PROJECT: Lake Mead Rock Springs Commercial Subdivision - update

# CITY OF LAS VEGAS INTER-OFFICE MEMORANDUM

**Lake Mead Rock Springs Commercial Subdivision - Update**

### 4<sup>th</sup> Submittal: Update #1 to revise the site layout at the southeast corner of the development

**GRADING PLAN**

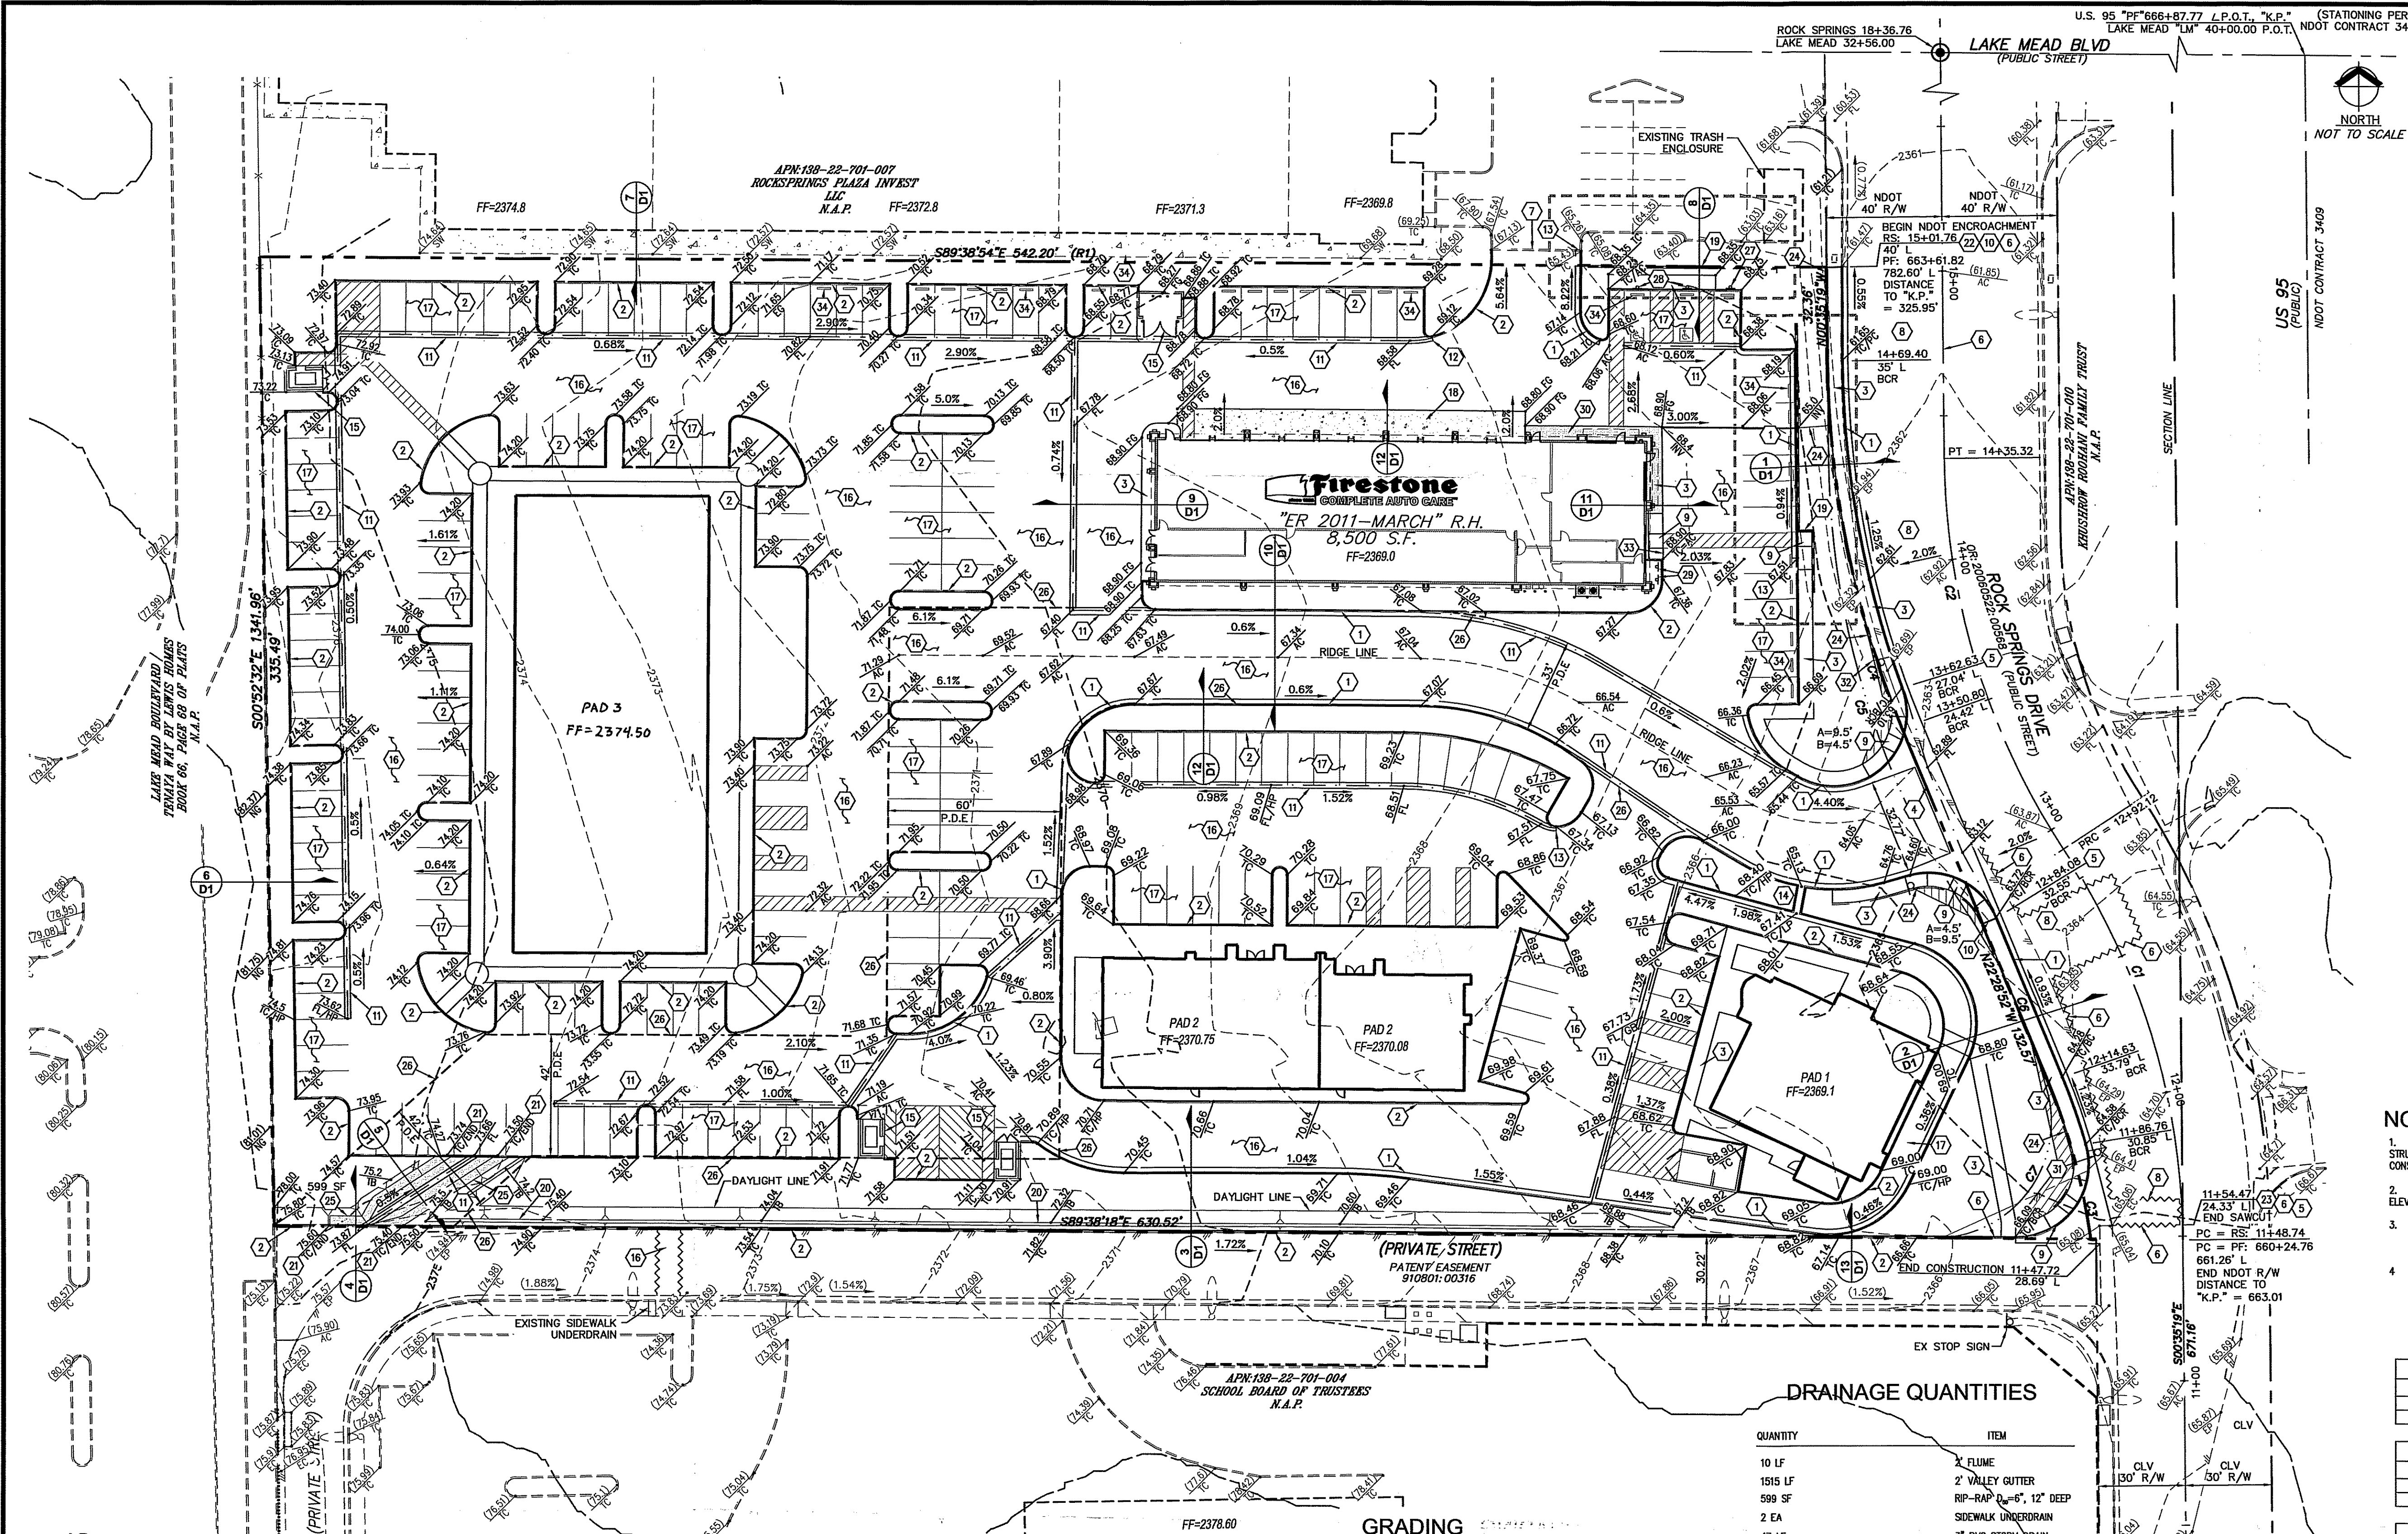
1. It appears that the handicapped parking areas exceed the ADA 2%-max. slope criterion. Review and revise accordingly.
